# Horsley Witten Group

Re: Site Plan Review- Response to comments  
Mill 77 Redevelopment  
77 Elm Street  
Amesbury, MA

Re: Response to Peer Review Comments  
Proposed Mixed-Use Commercial Development – 77 Elm Street  
Amesbury, Massachusetts

**Figure 6R**  
**Project-Generated**  
**Peak Hour Traffic Volumes**

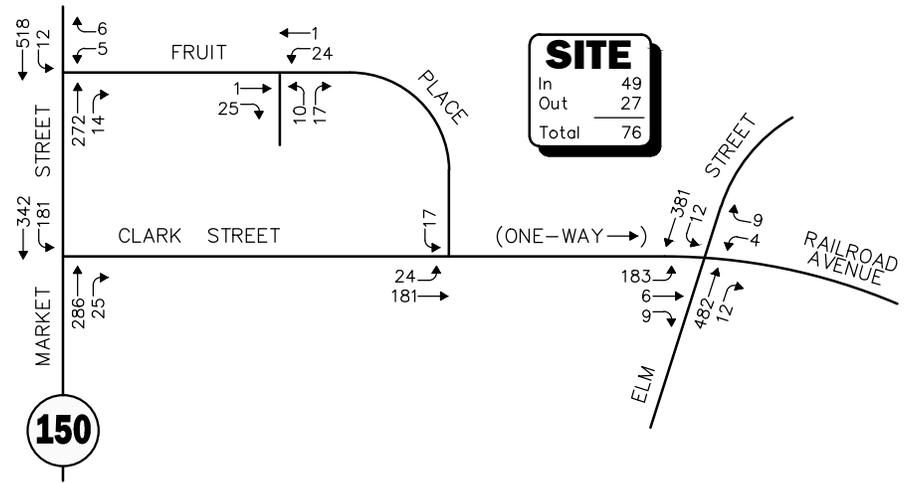
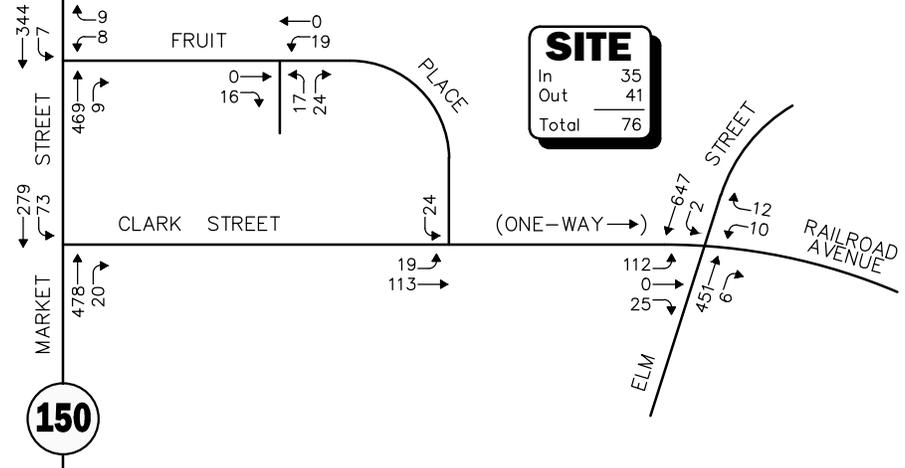
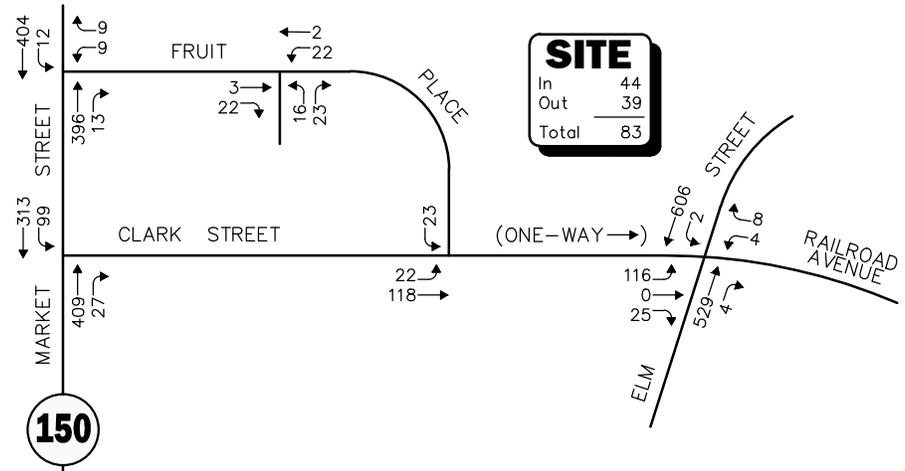
**Comment 7 ii.** *As shown in Figure 6, all project trips including 49 entering trips during the morning peak hour and 39 entering trips during the evening peak hours are routed to Fruit Place and Fruit Place Extension yet there are only 23 parking spaces provided. Where are the other parking spaces for the estimated trips to serve the site?*

**Response:** If the arriving vehicles are unable to find a parking space within the proposed parking lot that is to be constructed off Fruit Place, employees and patrons of the Project would use public parking available in the area, including on-street parking along Market Street and Water Street, and in the municipal parking lot located off Water Street, all of which are within a reasonable walking distance of the Project site. If and when off-site parking is used, Project-related traffic assigned to Fruit Place and Fruit Place Extension would be less than that predicted in the December 2015 TIA thereby resulting in a less pronounced impact on these roadways and greater dispersal of trips.
